HI-MILL MANUFACTURING COMPANY
FINAL TECHNICAL MEMORANDUM

Revision #3
Master Copy

June 1991

Below are comments concerning the Hi-Mill Manufacturing Draft Technical Memorandum from Karla Johnson of the USEPA (#1-#10), Murat Akyurek of Donohue & Associates (#11-#21) and Deborah Larson of the MDNR (22-#26). Each comment/concern from the agency is followed by a corresponding response from Geraghty & Miller, Inc.

FIGURE 33
TCE/DCE CONCENTRATIONS
MARCH 14 & 23, 1990
SHALLOW MONITORING WELLS
HIMILL MANUFACTURING
HIGHLAND MICHIGAN

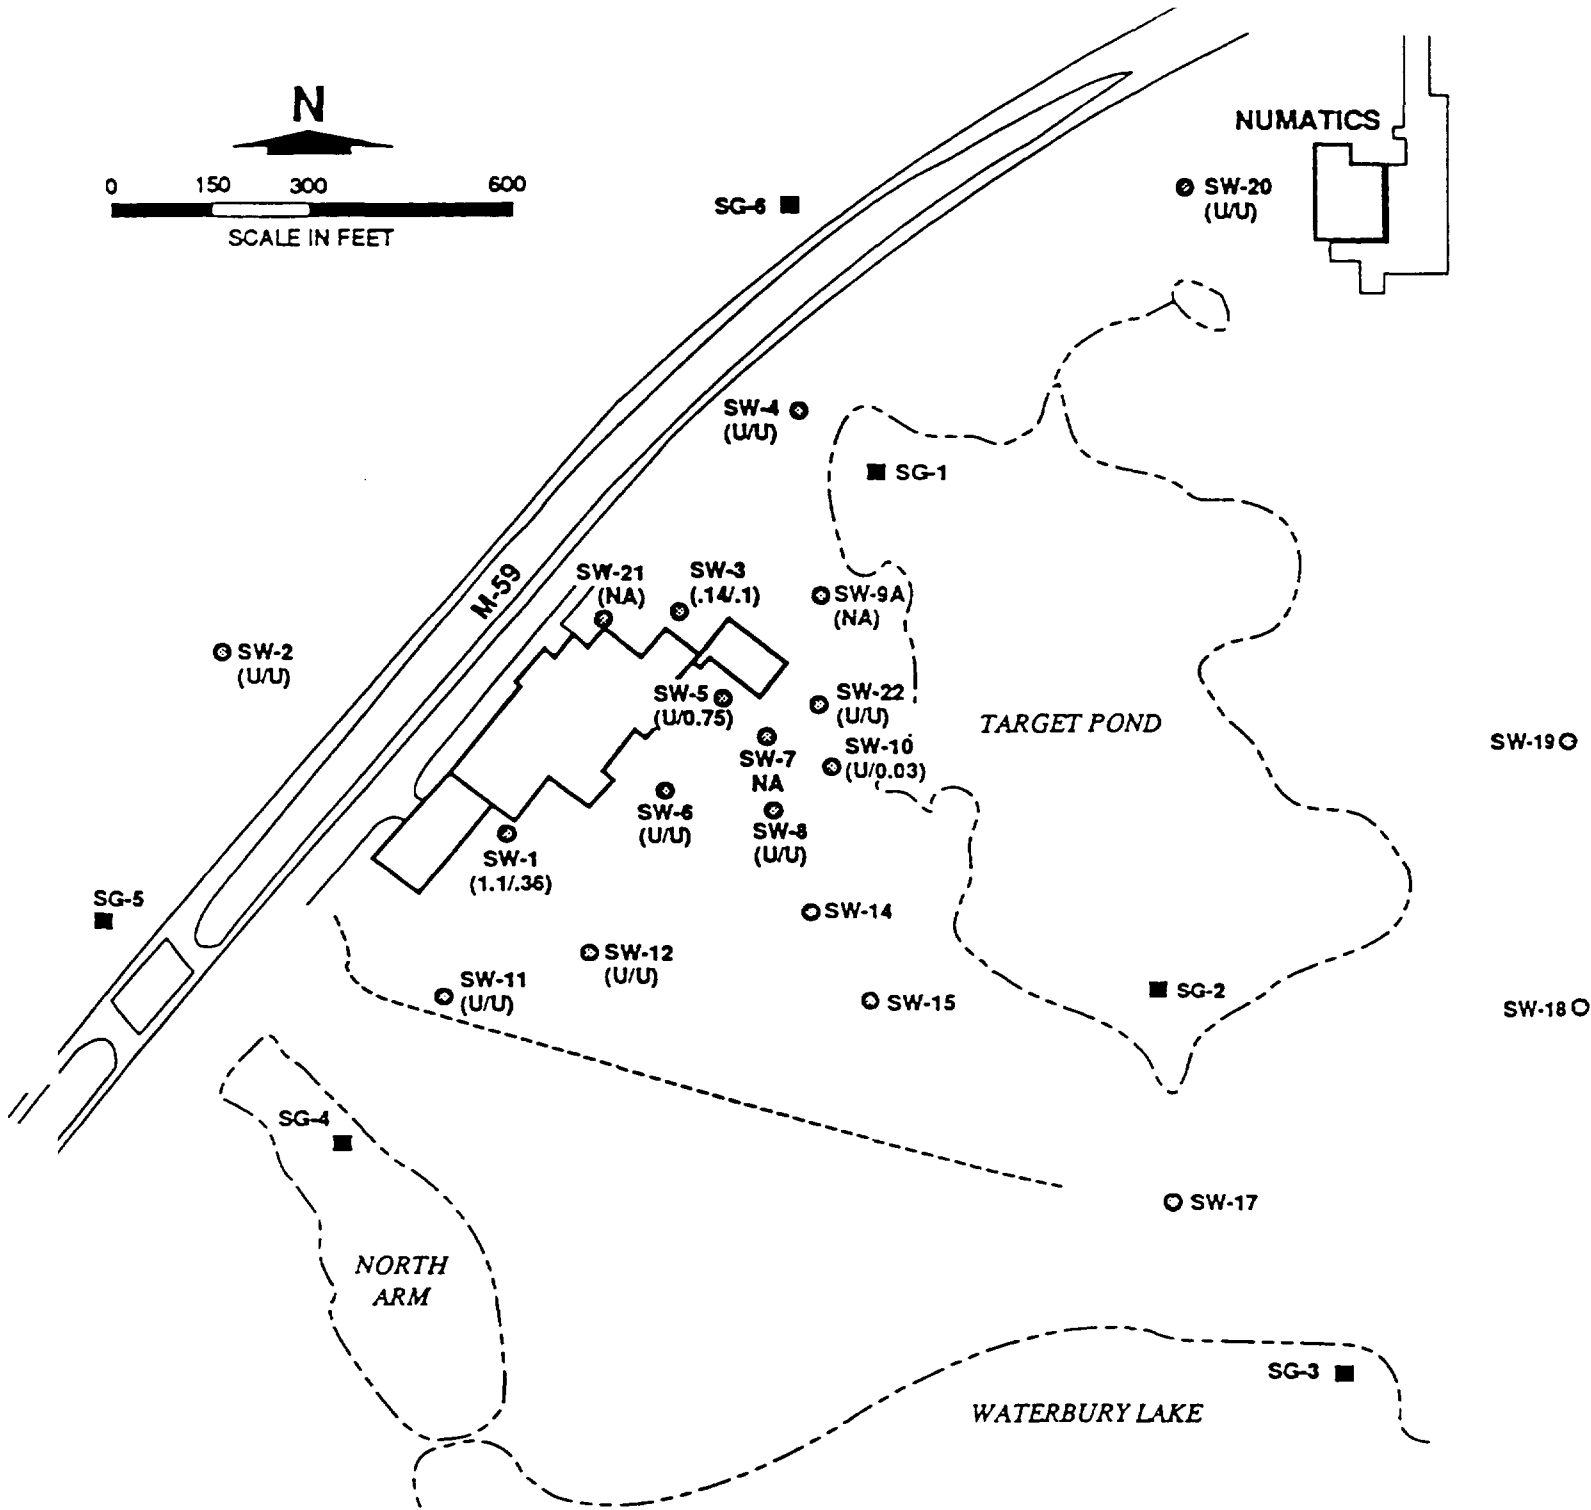
- 10 13/2 C: Figure 33 is missing.
R: Typographical error, Figure 34 was misnumbered and is now numbered as Figure 33.
- 11 4/1 C: Locations for the six staff gauges are shown in Figure 7 rather than Figure 6.
R: Typographical error, text has been changed to "Figure 7".
